Wisconsin Electric POWER COMPANY
231 W. MICHIGAN, P.O. BOX 2046, MILWAUKEE, WI 53201

DOCKET NO. STN 50-502
ADDITIONAL INFORMATION - ENVIRONMENTAL REPORT
HAVEN NUCLEAR PLANT

Enclosed are Applicants' responses to your request for additional information regarding the Environmental Report - Haven Nuclear Plant as transmitted by your letter dated May 15, 1979. We are providing 25 copies of these responses.

Figure 36-1 is a site map showing soil types, and Table 36-1 provides a description of the mapping units.

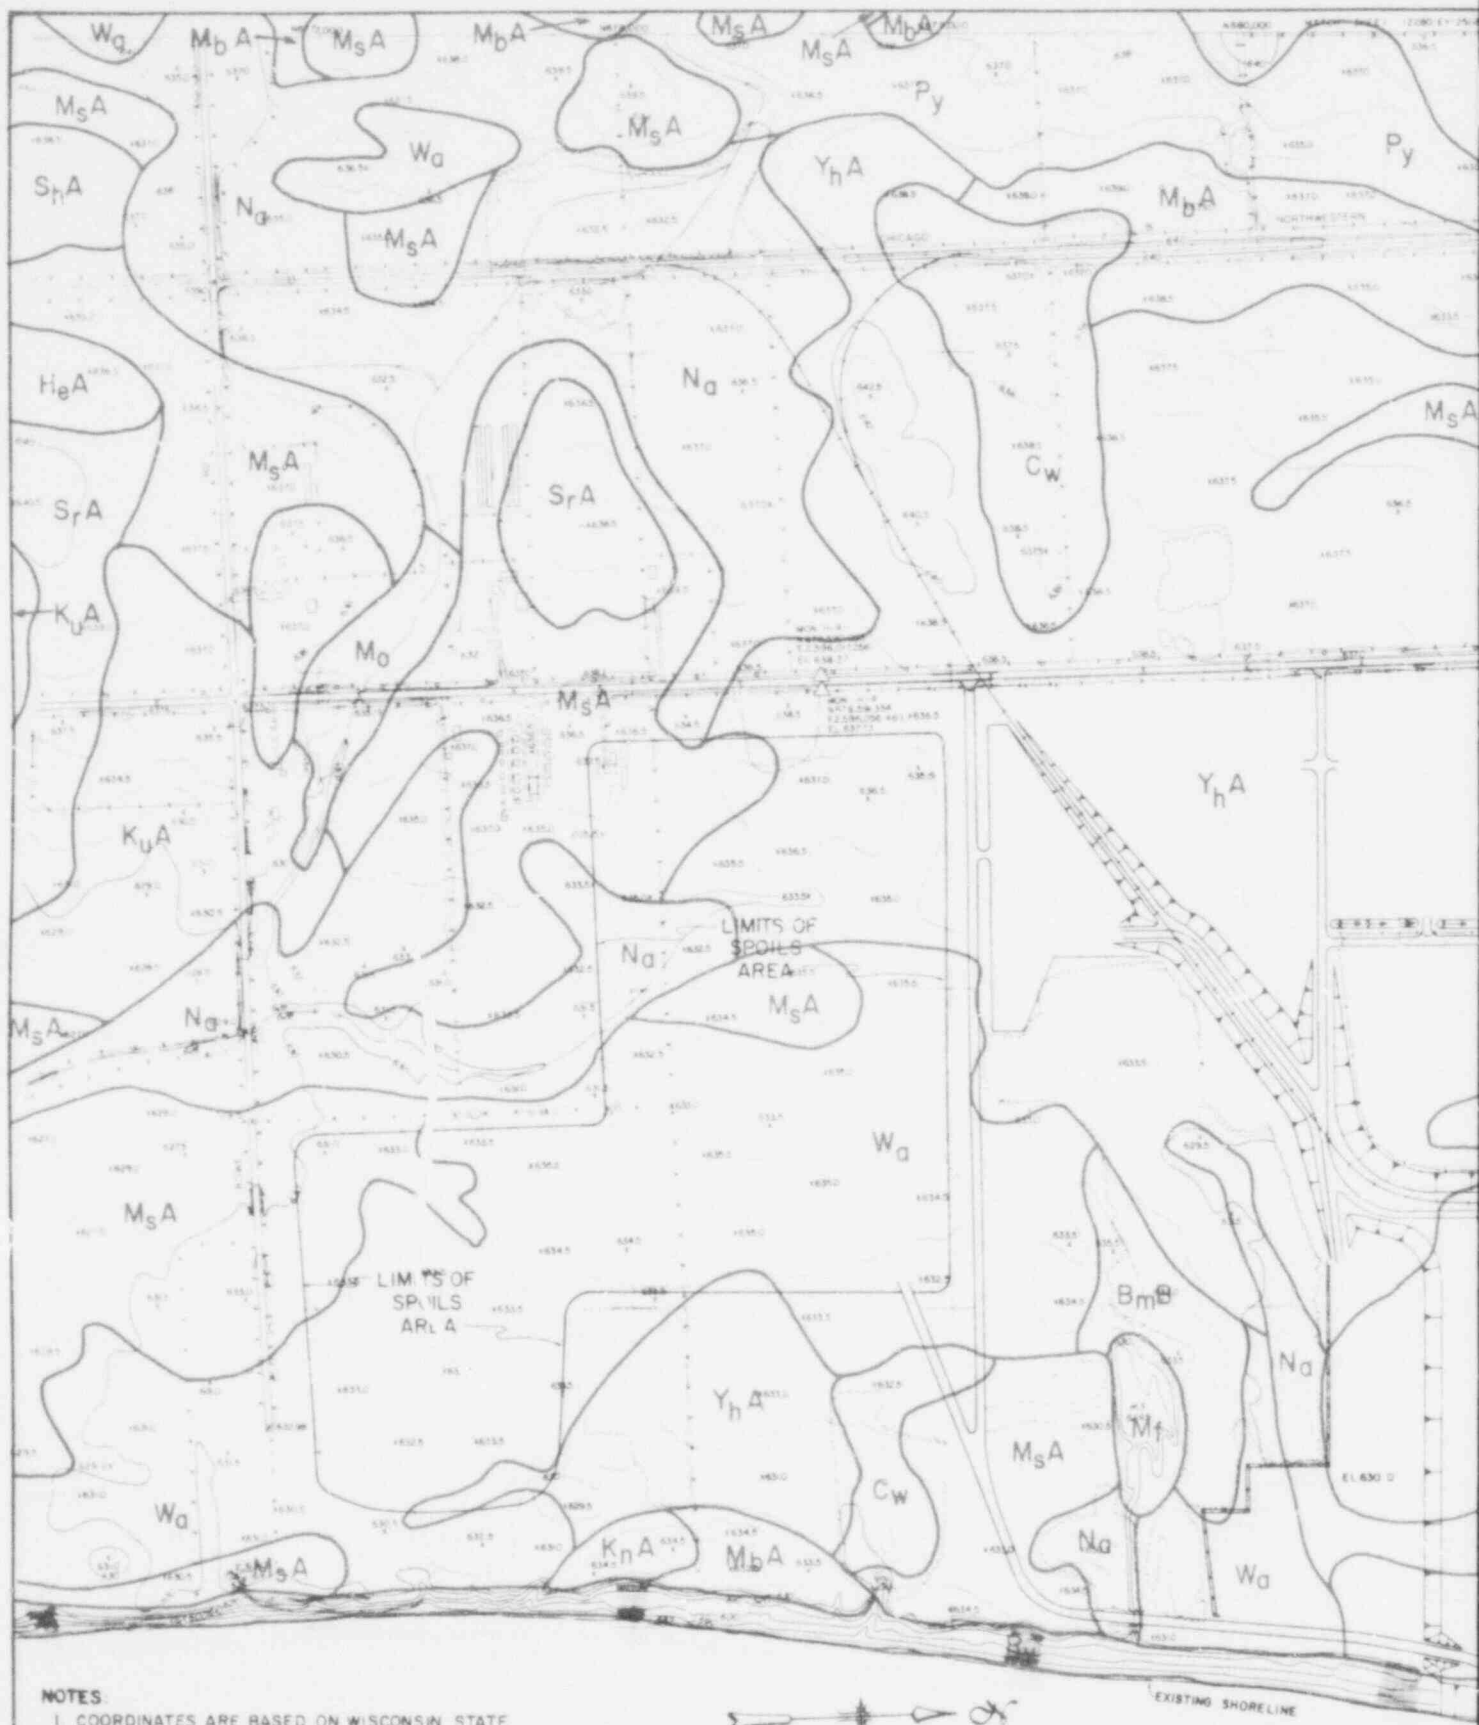
Provide a site map showing soil types accompanied by a description of the mapping units.
